Chandler, April 8th, 2021

USB CONNECTOR CHANGE NOTICE

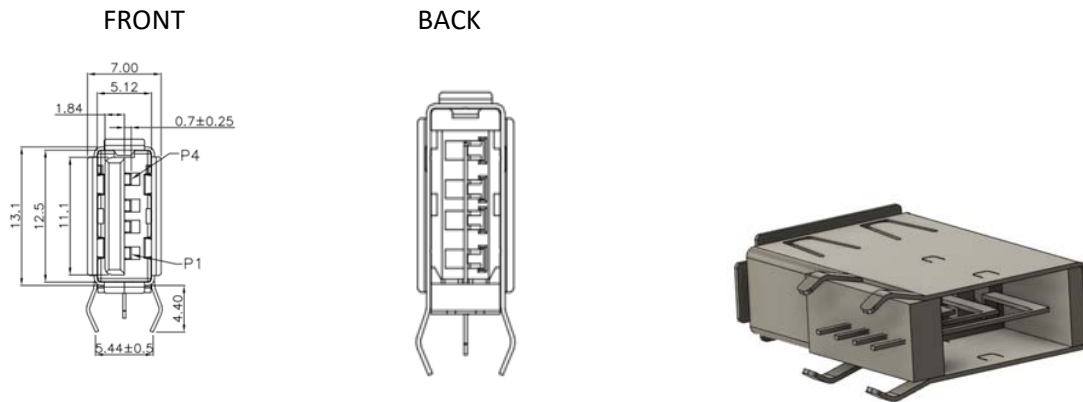
1002-014-01000 with a date code AFTER 20/02 does not come with the back portion of the shell.

Shown in the drawing uploaded:

Please review comparison drawing and the step file for design, dimensional and tolerance changes.
